YARRA CITY COUNCIL
Internal Development Approvals Committee
Agenda

**to be held on Wednesday 10 June 2015 at 6.30pm
in Meeting Room 3 at the Richmond Town Hall**

-
- 1.1 PLN14/0846 - 11 - 13 Spring & 14 - 16 Argyle Streets, Fitzroy - Partial demolition and development of the land with the construction of four buildings, ranging between four and five storeys in height (plus basement and roof terrace) for fourteen (14) dwellings (permit not required for the dwelling use) and a reduction in the car parking requirements.**
-

1. This report provides Council with an assessment of planning permit application No. PLN14/0846 which affects land at 11-13 Spring & 14 – 16 Argyle Streets, Fitzroy and recommends approval subject to conditions.

2 SECOND FLOOR PLAN

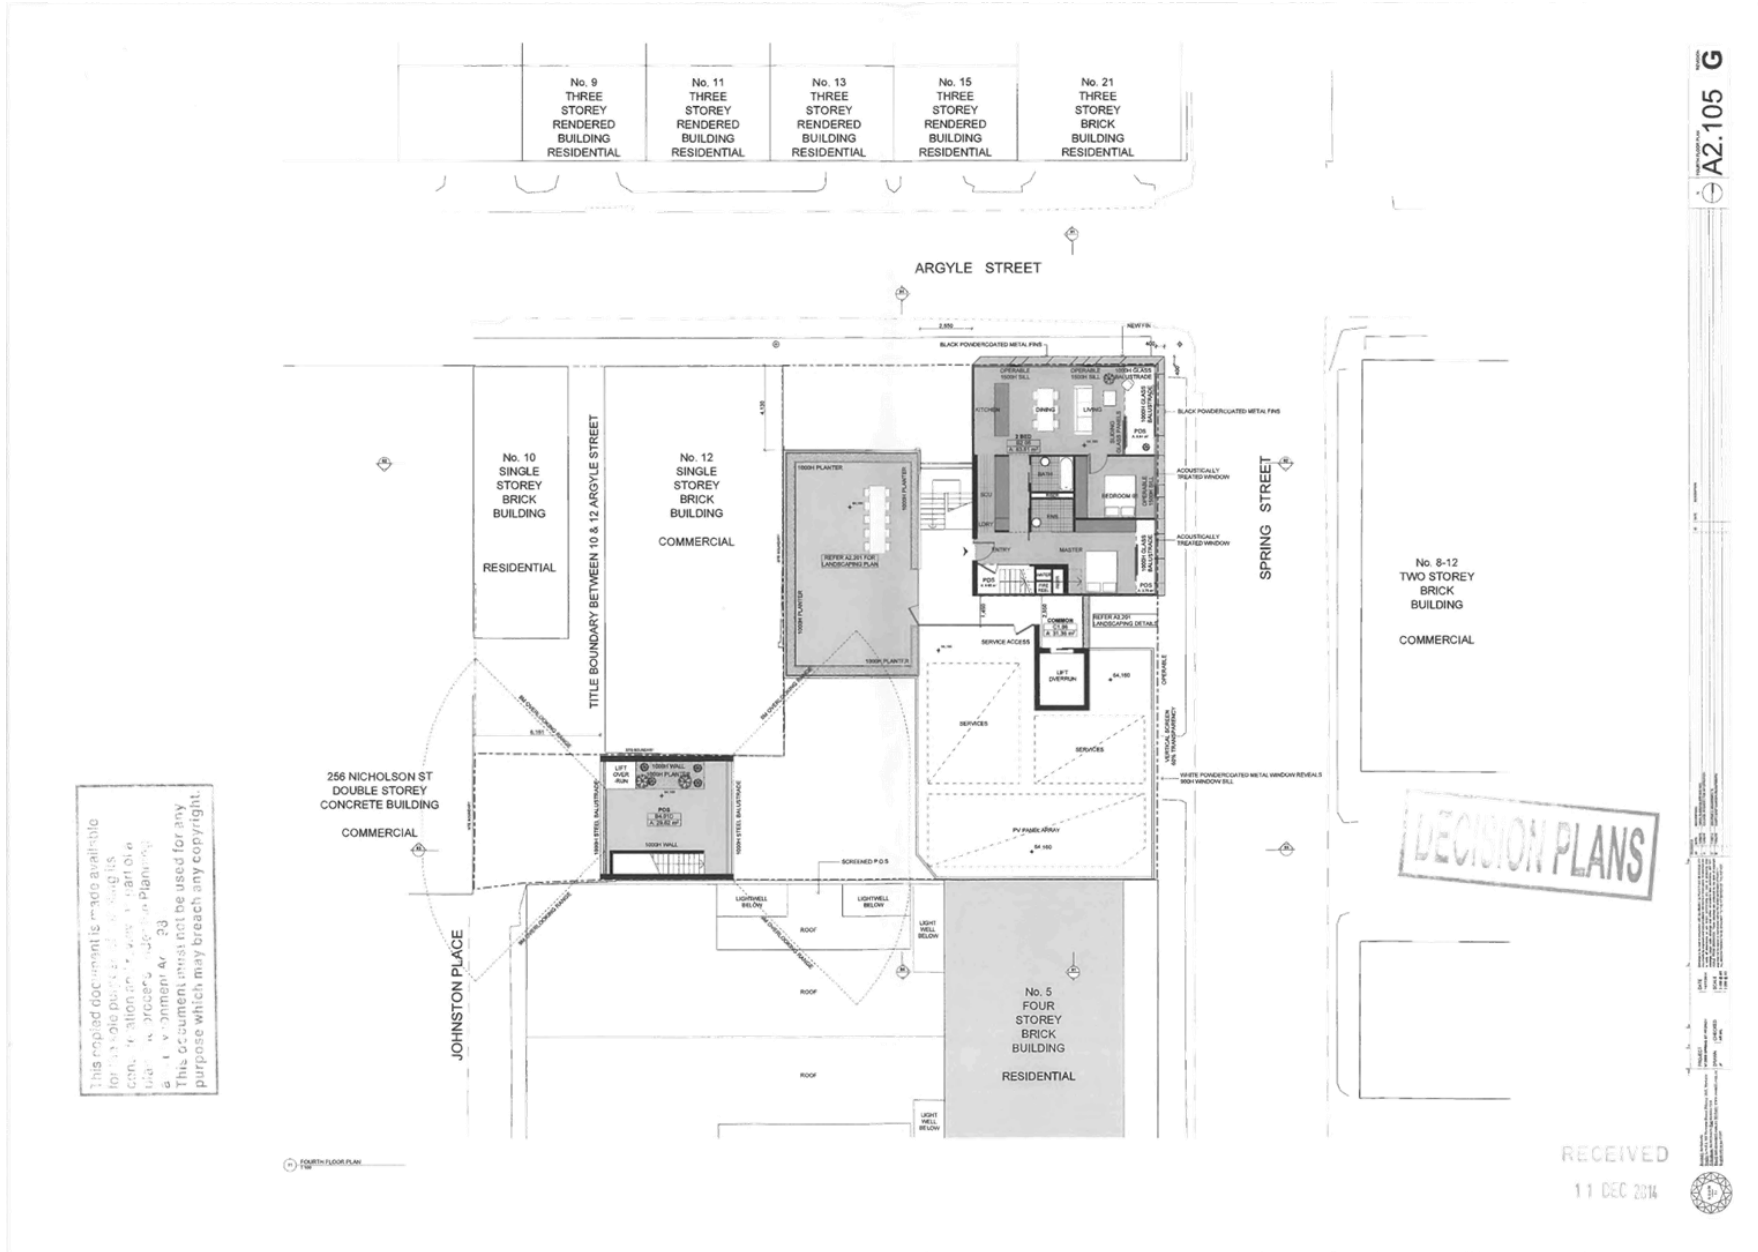
158. One outstanding issue is the balcony balustrade on the second floor. The floor plans and perspectives show a balcony directly abutting the front façade of Building 1. This was a matter which was of concern to both Council and the Tribunal in the previous decision.

Figure 2: Central mullion extended to fire booster cabinet, outlined in blue.

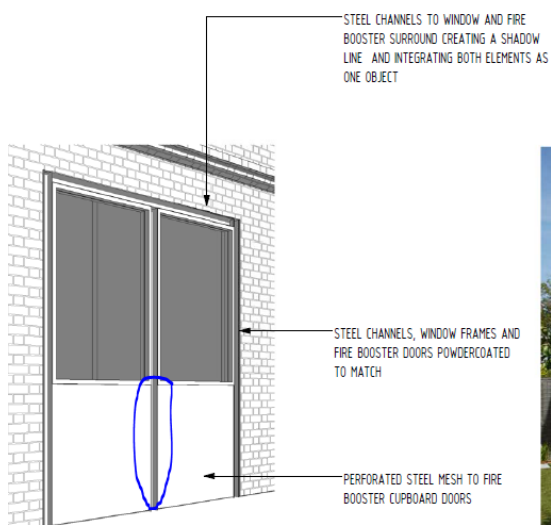
However, the MFB have rejected this concept on the basis that fire booster being in this location, when utilised would prevent access into the shops for firefighters and out of the shops for occupants. Given the MFB's strict safety guidelines for access to these facilities, there is little that can be done about the fire booster's location. It would be unreasonable to say that the applicant has taken this matter lightly, and has not exhausted location and design options, whilst still allowing for an acceptable retail frontage at ground level. They have elected to use the smallest possible booster size allowed, and working with Council Officers to improve the situation. On this basis, the pragmatic approach would be to accept the proposed location of the booster cabinet and see what improvements can be made to allow the best possible outcome from both an urban design and heritage perspective. One way is to extend the central mullion of the window above down to the booster cabinet doors, to give a greater emphasis and impression of a door entry in this location, as per the sketch below. While the change may seem insignificant at face value, it would provide a greater reference to reflect the original door entry location. This can be facilitated via a permit condition.
